Addendum No.: 1

Bid#: 24-15-2

Project Name: Meadow Lake & River Oaks New Elevated Storage Tanks

SHEET NO.
CP-002
SHEET 2 OF 2

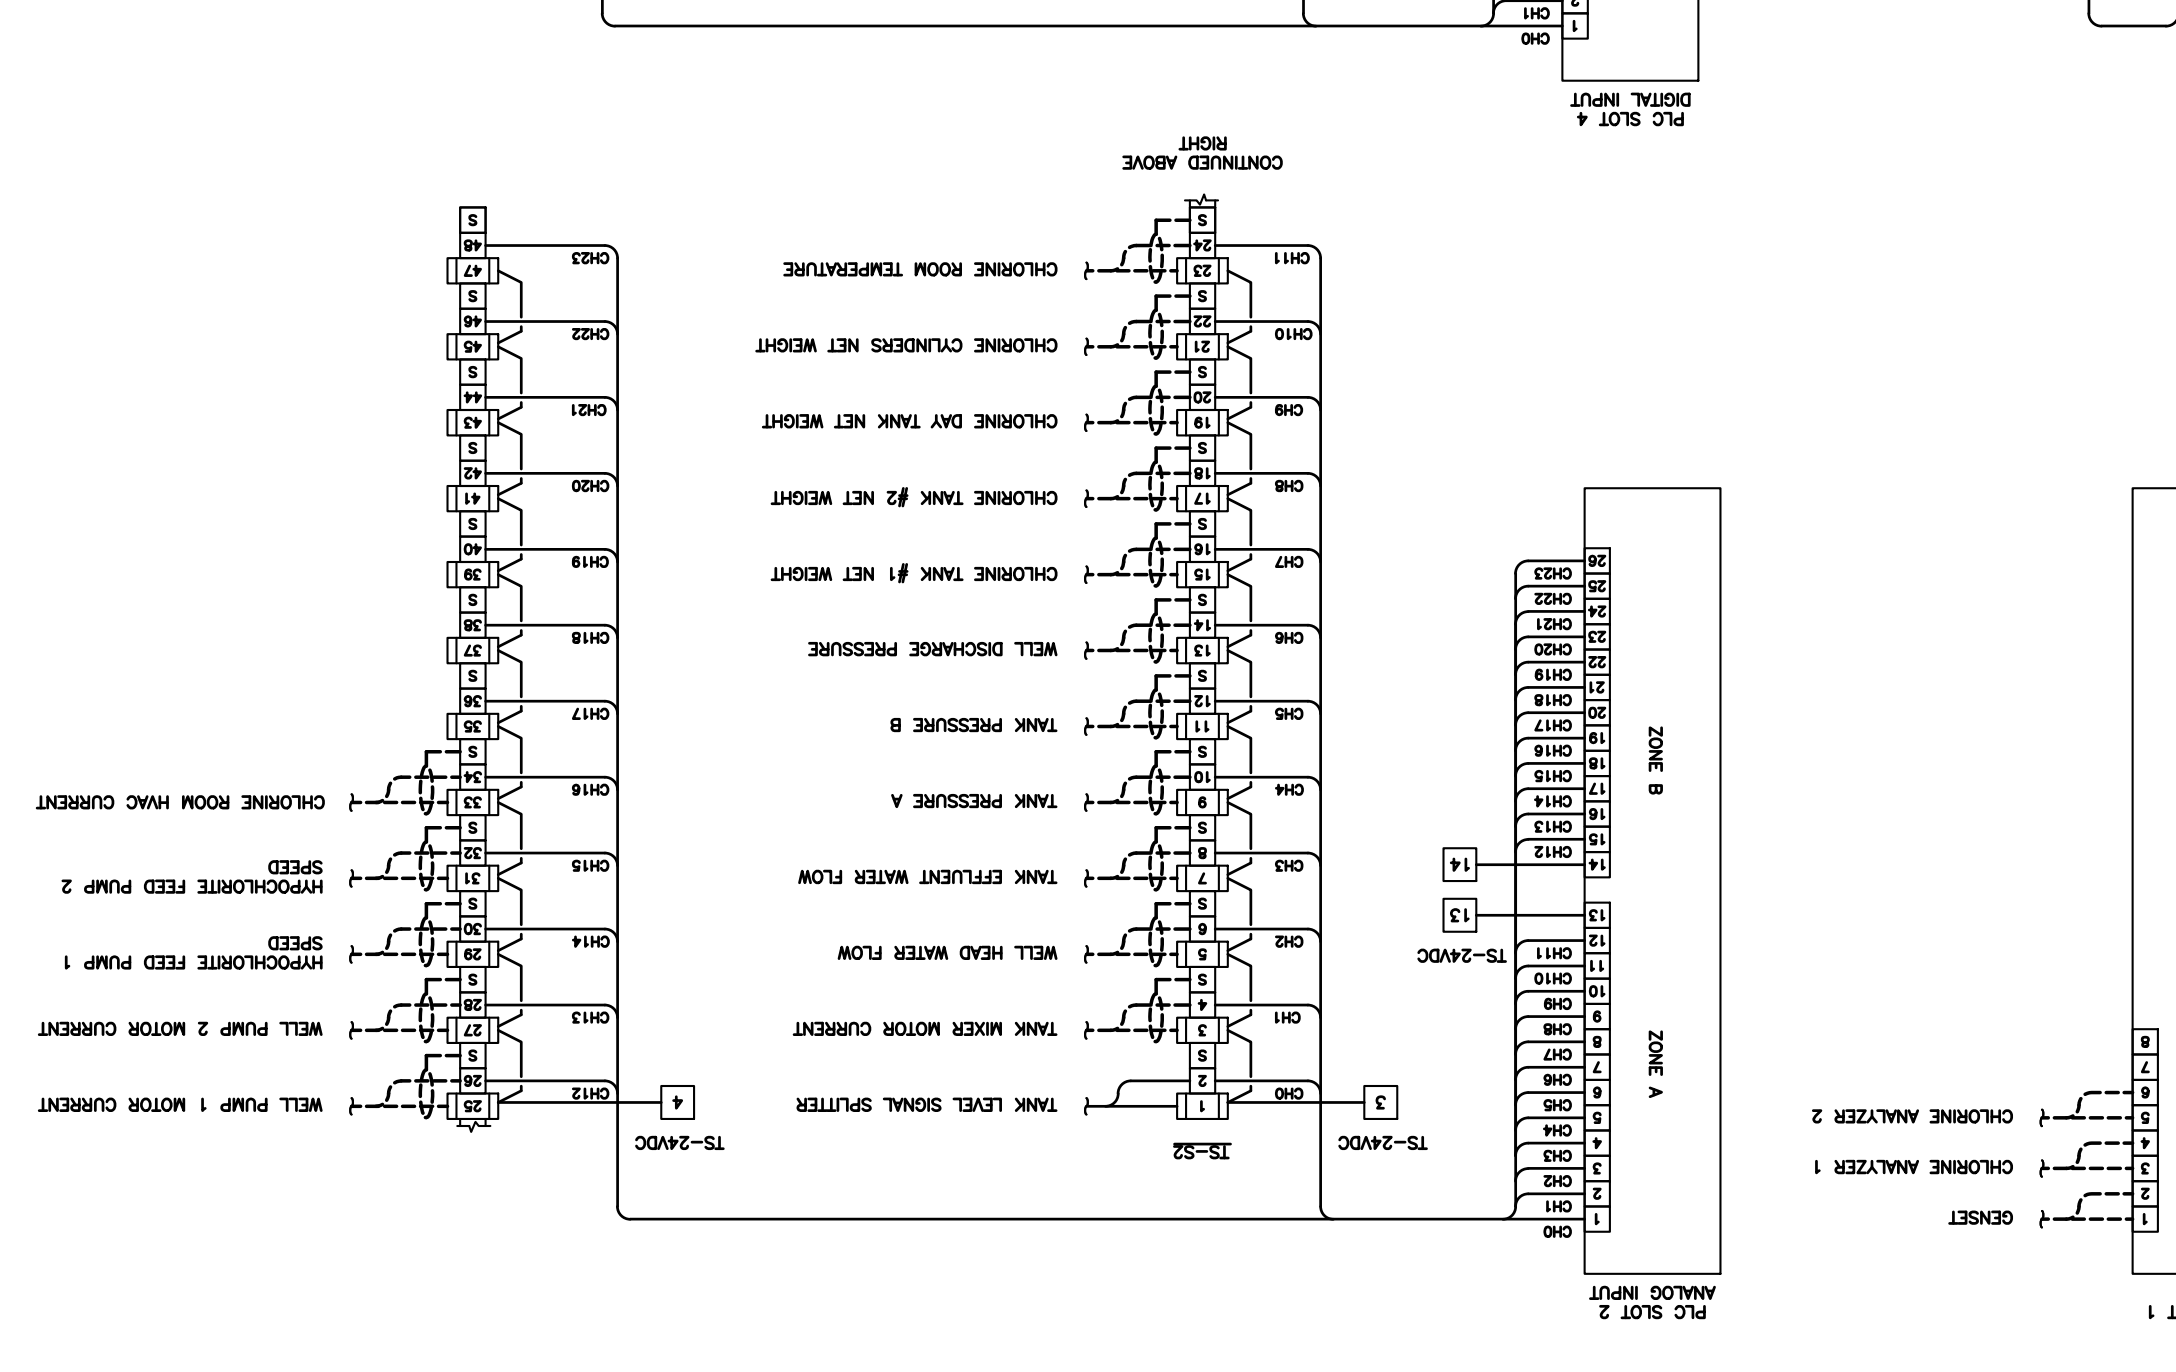
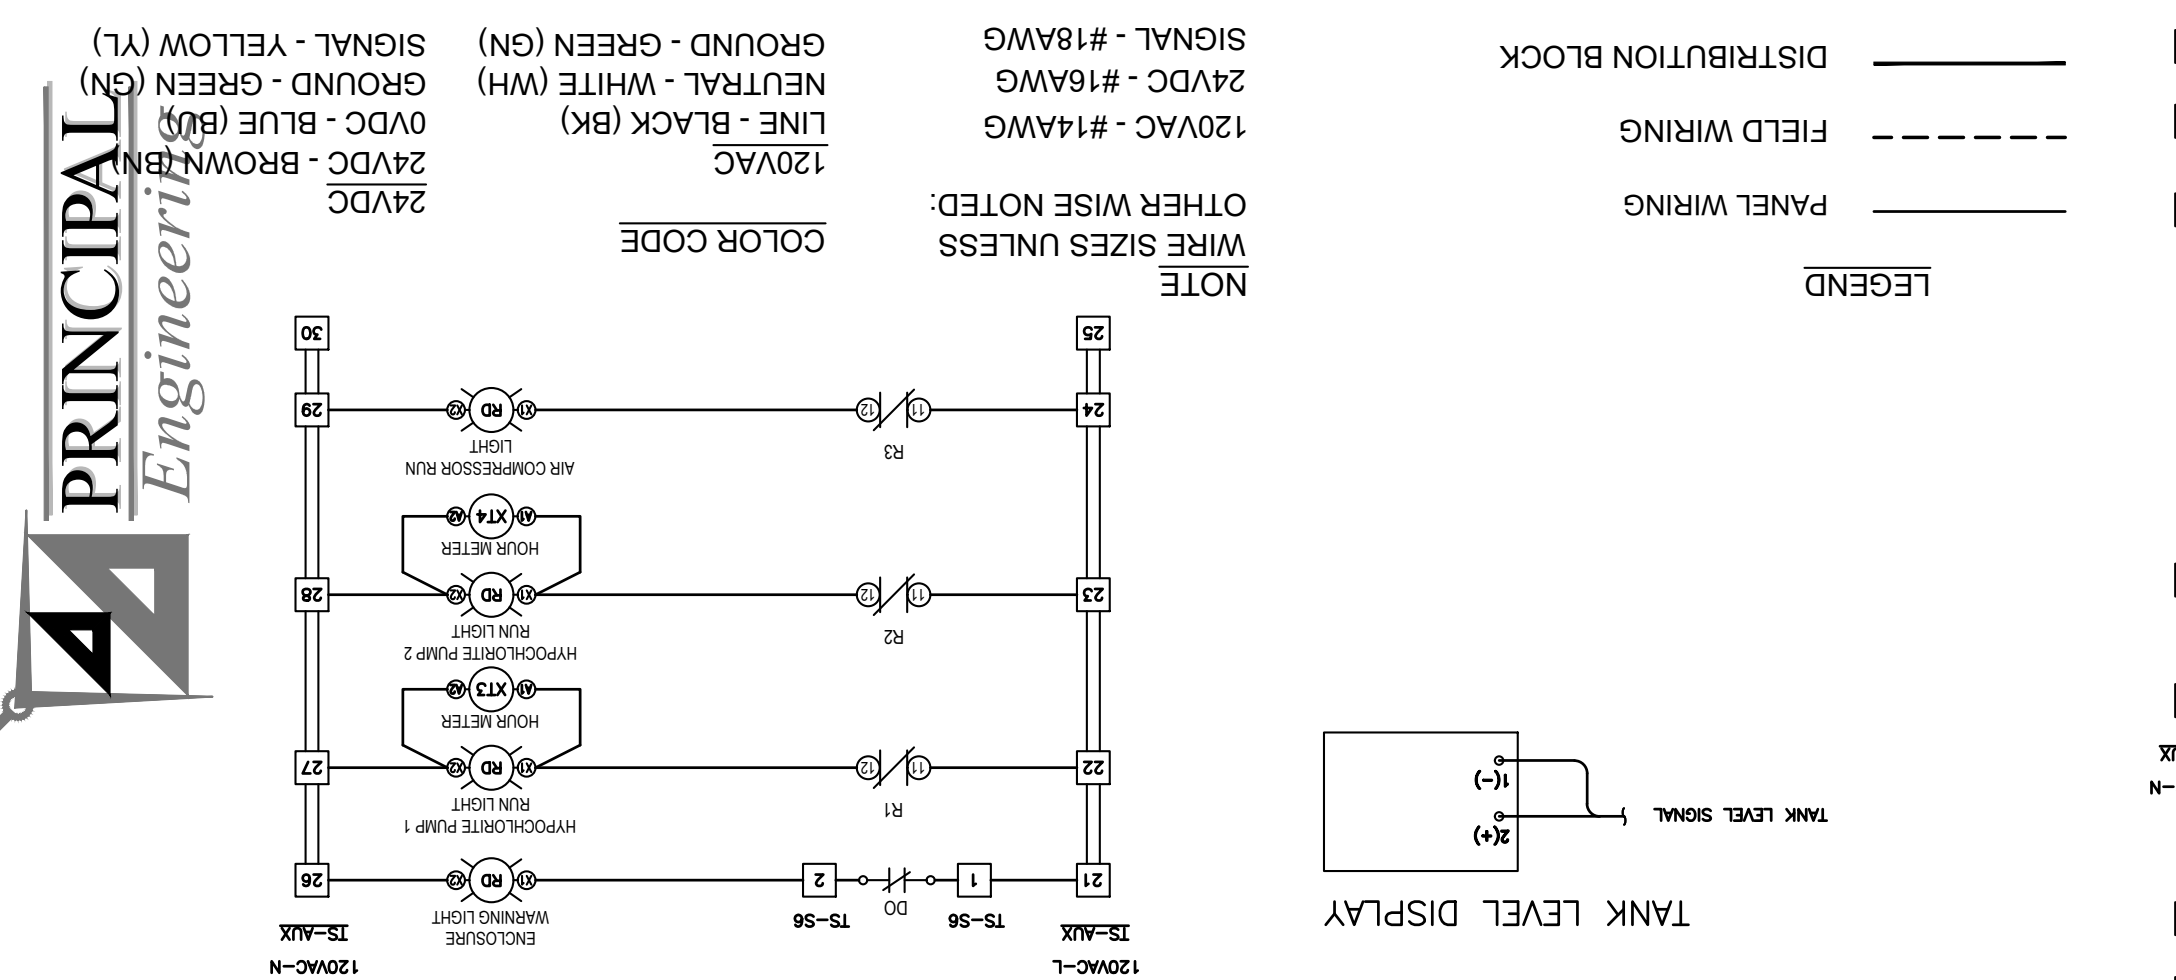
No.	DESCRIPTION OF REVISION	DATE
1	UPS AND BATTERY ADDED	04/25/24

GENERAL NOTES & LEGEND

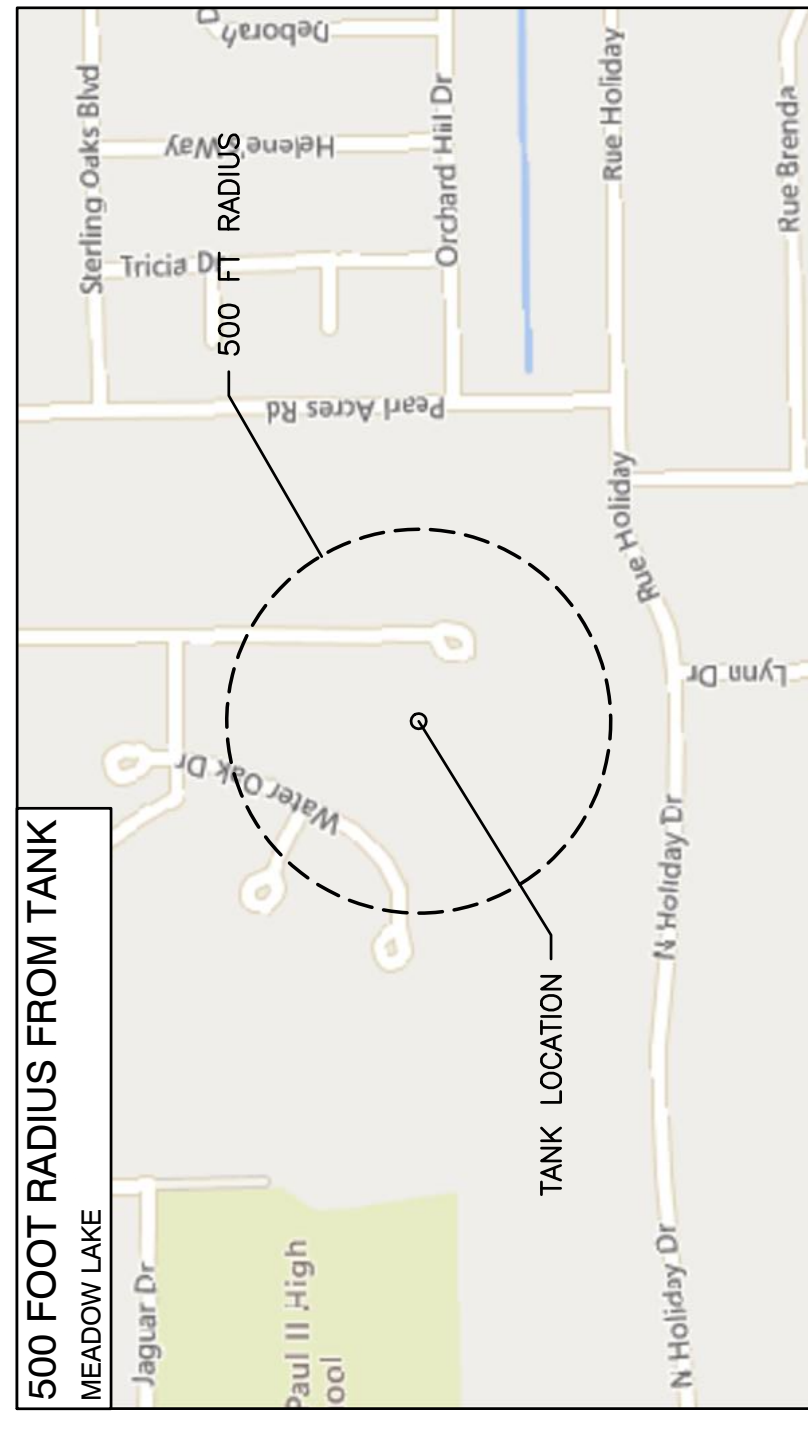
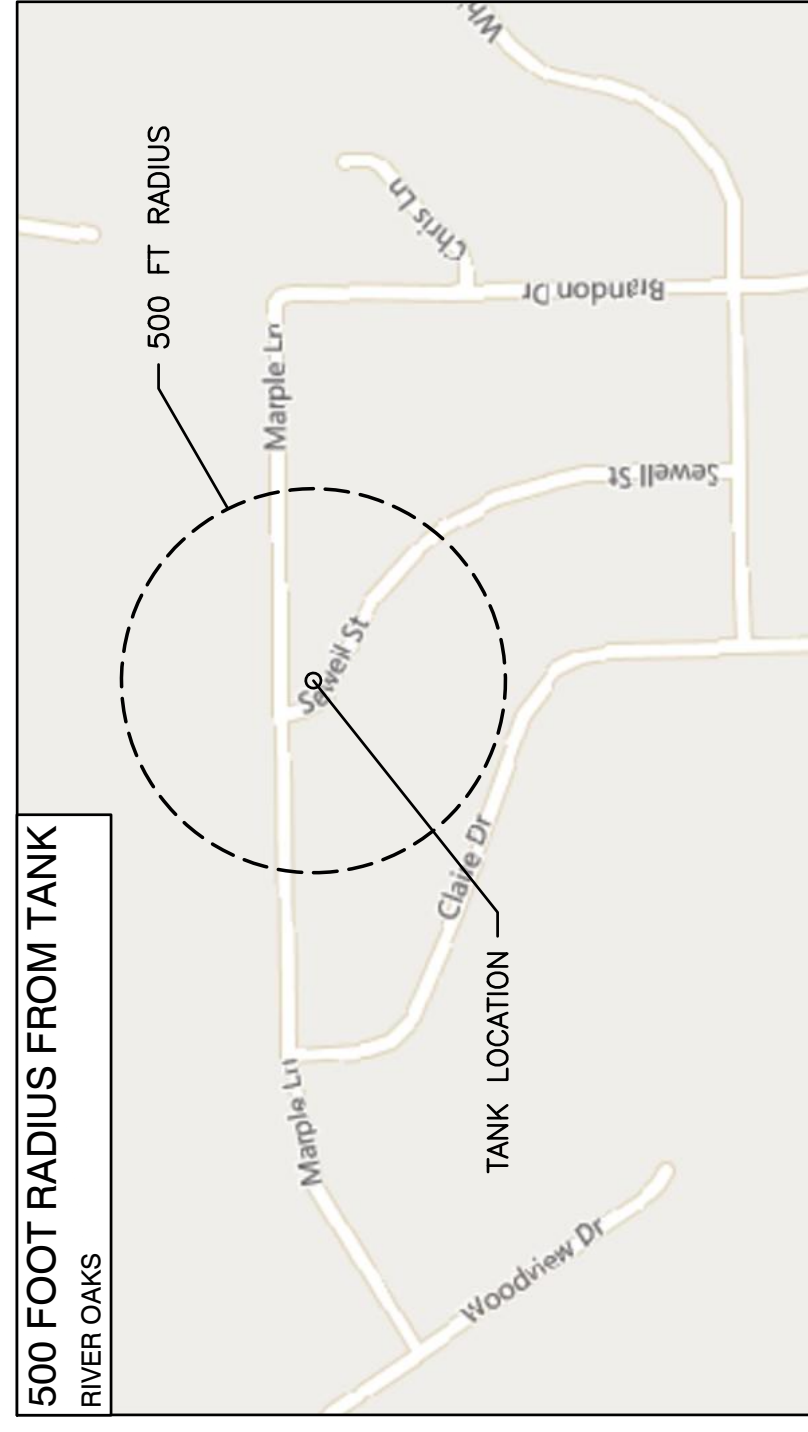
1	ADDED GEN. NOTE #1. ADDED 500 FT	DATE:
	DESCRIPTION OF REVISION

- A SITE CONDITION SURVEY IS REQUIRED AT BOTH SITES

MEADOW LAKE & RIVER OAKS
NEW ELEVATED STORAGE TANKS
SLIDELL, LOUISIANA
PROJECT No. (R0): TU23000160
PROJECT No. (ML): TU23000159
MEADOW LAKE DEMO PLAN

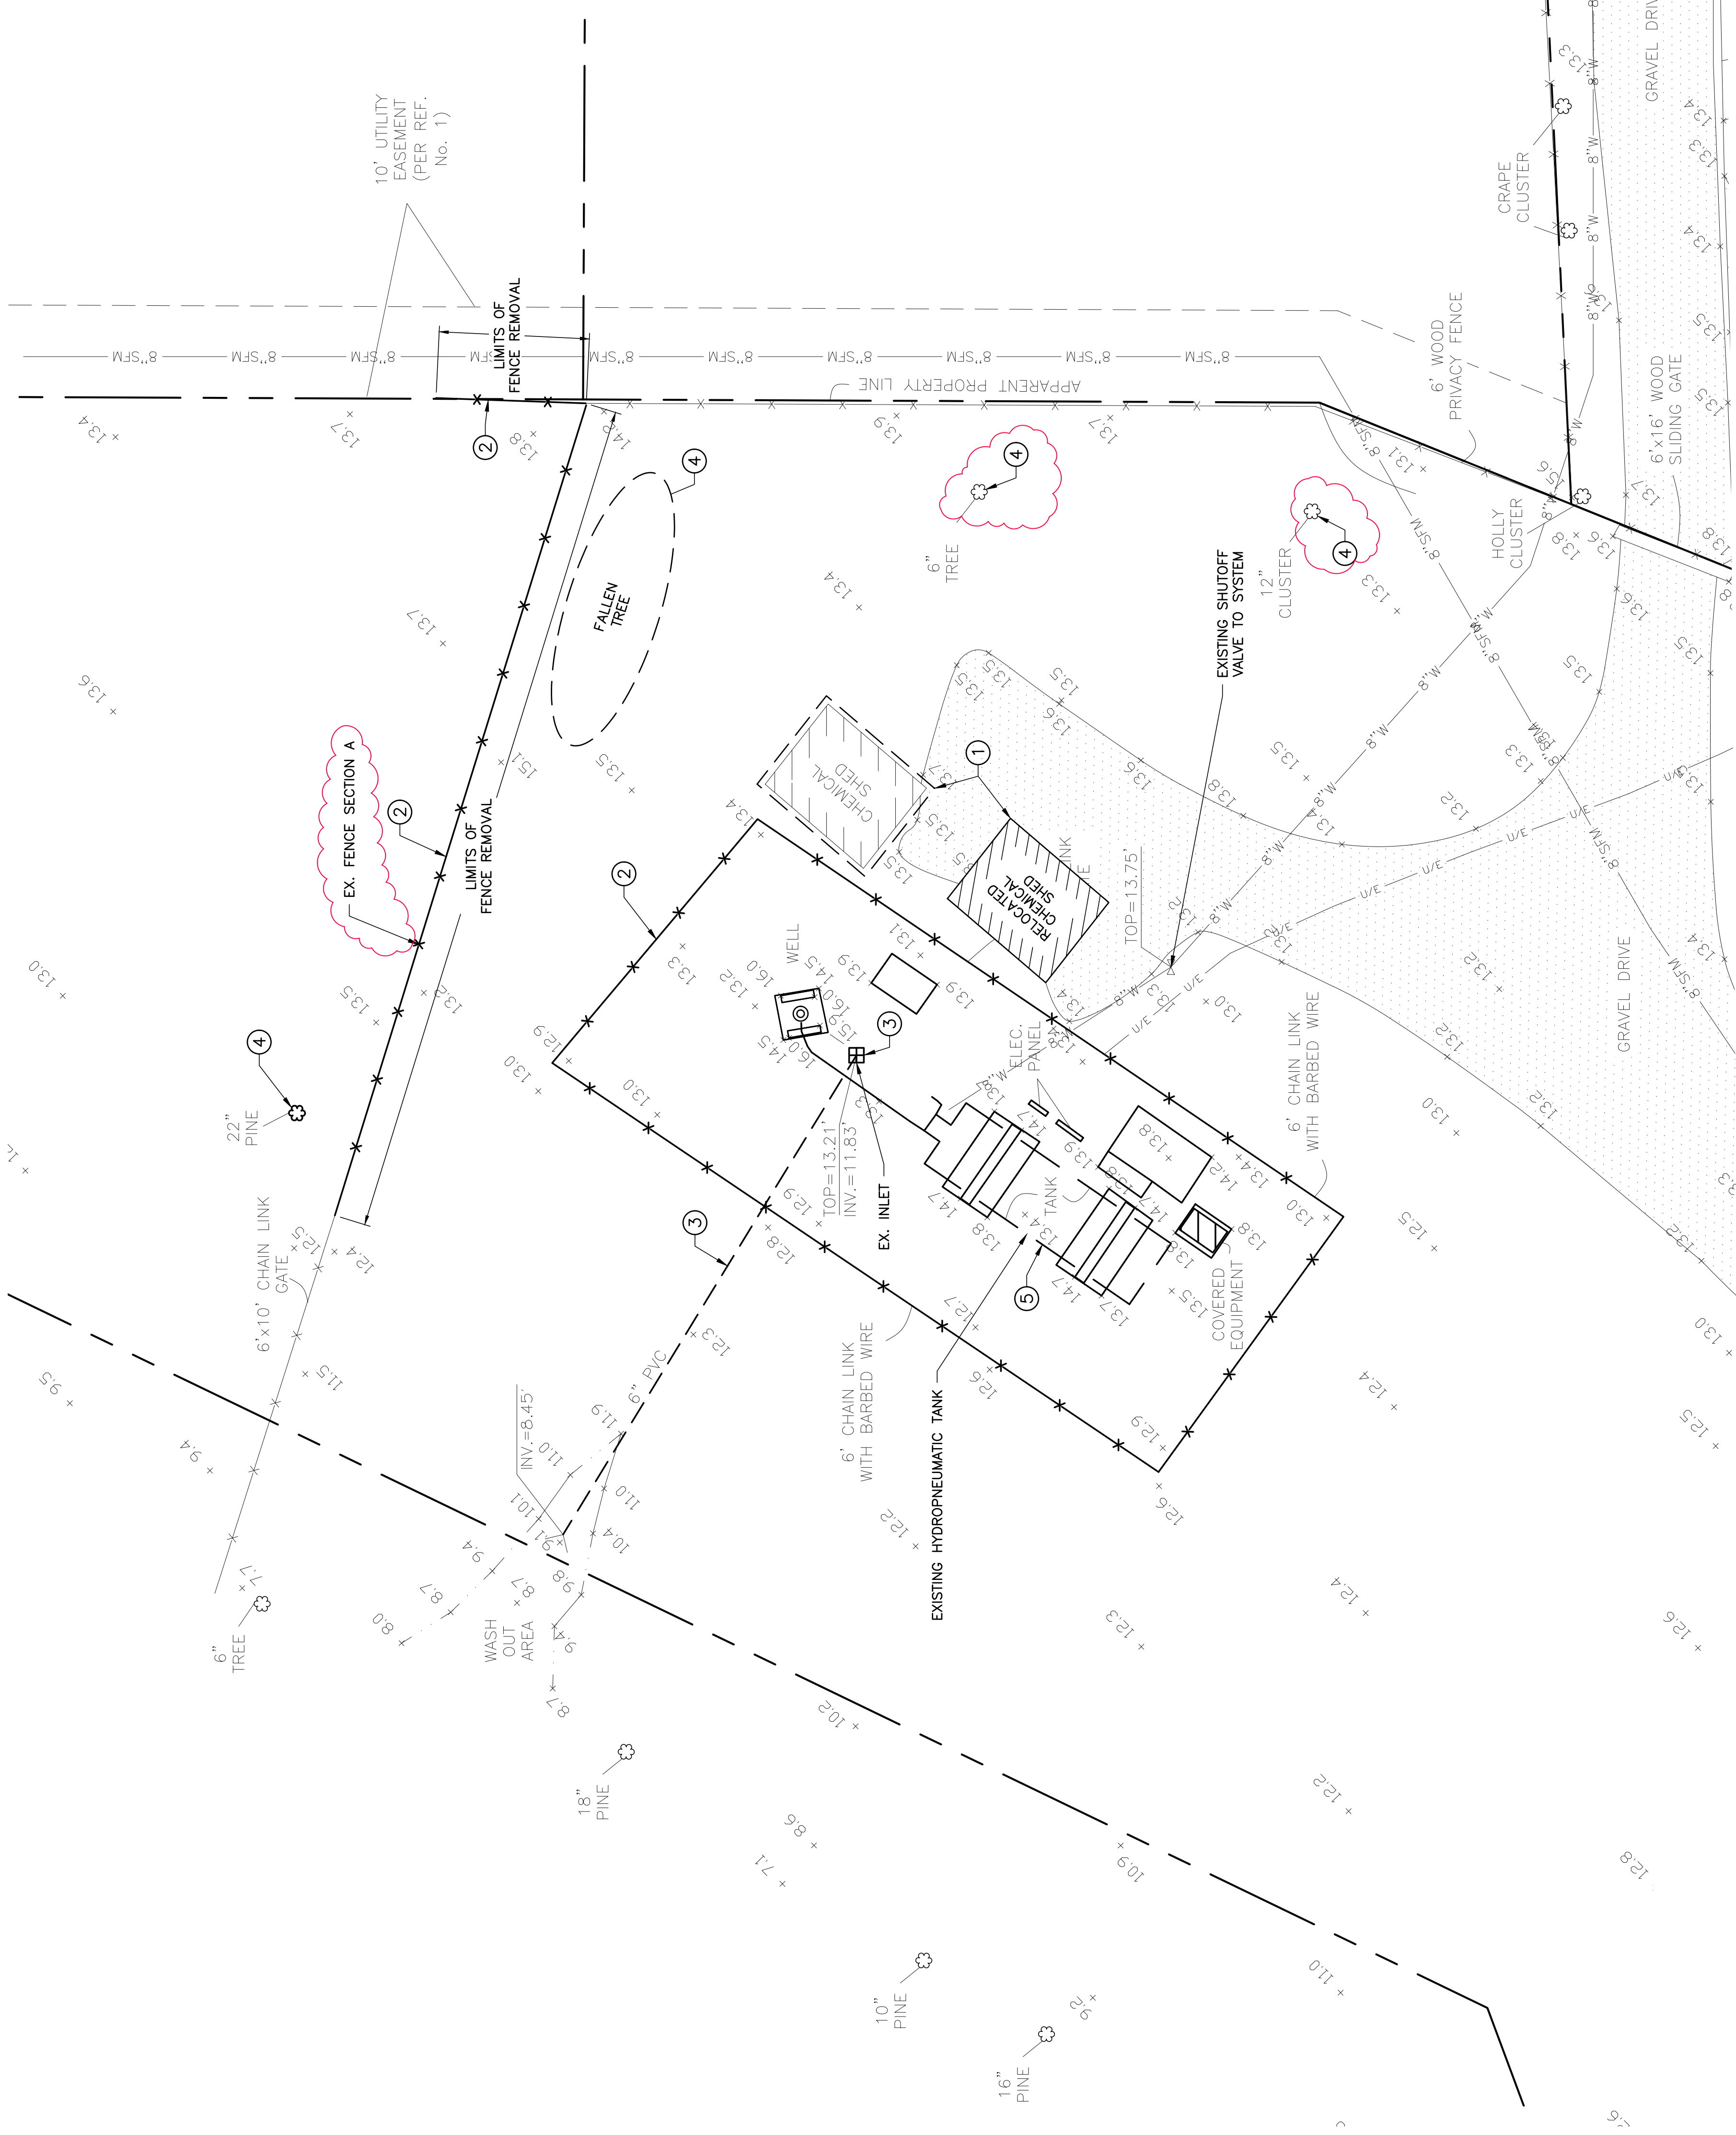
No.	DESCRIPTION OF REVISION	DATE:
1	ADJUSTED KEYNOTE 2. ADDITIONAL TREE REMOVAL.

- 1 RELOCATE EX. CHEMICAL SHED
- 2 REMOVE EX. FENCE, TREES, BUSHES, & SHRUBS WITHIN 5 FEET OF THE FENCE (SECTION A) TO THE LIMITS INDICATED.
- 3 REMOVE EX. 6" PVC DRAIN & DRAIN INLET
- 4 REMOVE EX. TREE
- 5 REMOVE EX. HYDRO TANK, FOUNDATION, & PIPING.
